Town of Parker Community Development Department
Development Review Division
Attention: **Krista Flynt**

Application Type: **Site Plan**
Status: **First Referral**
Application Name: **Parker and Pine F1 L6 – Everbrook Daycare**
Case/AP#: **SP20-058**
Referral Received: January 29, 2021
Comments Due: February 23, 2021

Review date: **February 16, 2021**
Plan reviewer: **Randall L. Capra, rcapra@parkeronline.org**
Phone: 303.805.3169

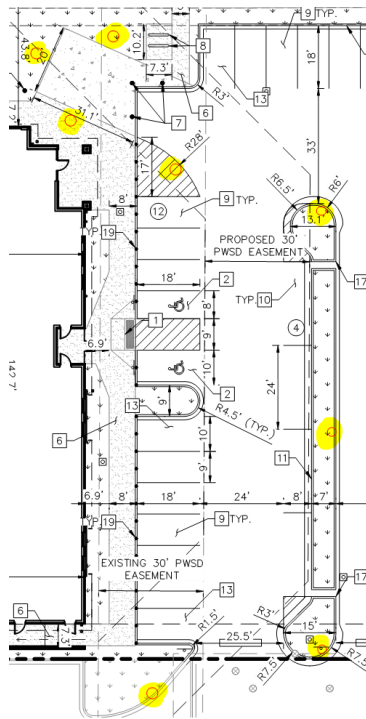
9. The playground areas shall be separated that each of the areas has two points of egress, separate by one half of the diagonal. Gates will be required to have panic/fire egress hardware and in each play yard, gates shall open in the direction of travel; this will require that two gates will be required when separating play yards to ensure that this provision is met.

Response: Acknowledged. Gate locations and swing direction updated. Hardware to be finalized during construction.

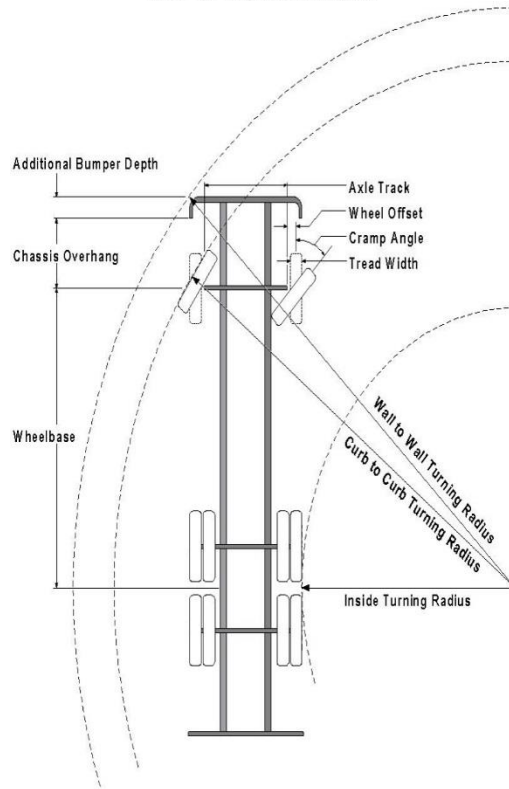
4. The applicant shall be aware that the access road hydrant distribution was not planned to address the suppression needs for all commercial properties within this subdivision; this site requires the addition of one hydrant (to be located at the s/w corner island of the building... as required per NFPA 24 Section 7.2.3... see the snap shot of the red-lined fire hydrant location shown under item 4 below:

Response: As discussed, the adjacent FH to the south (installed as part of the multi-family development) will fulfill this requirement.

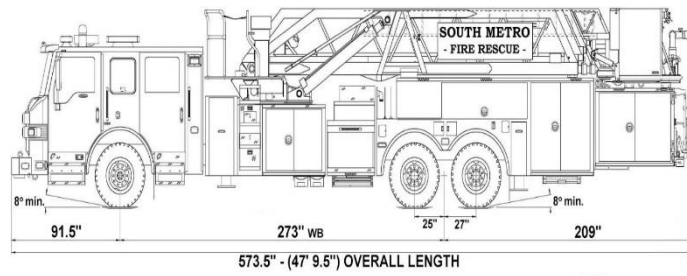
11. The construction drawings indicate that there are three proposed removable bollards to be placed at the hammer head required for site access; the applicant shall remove the bollards from the site plan as they are not allowed. Signage maybe placed that states EMERGENCY ACCESS ONLY on each side of the entry. No Parking – Fire Lane signage (with directional arrows pointing either direction) shall be placed on all three sides of the hammerhead. See below for fire lane signage areas.

Response: Acknowledged. Bollard removed to be outside of hammer head.
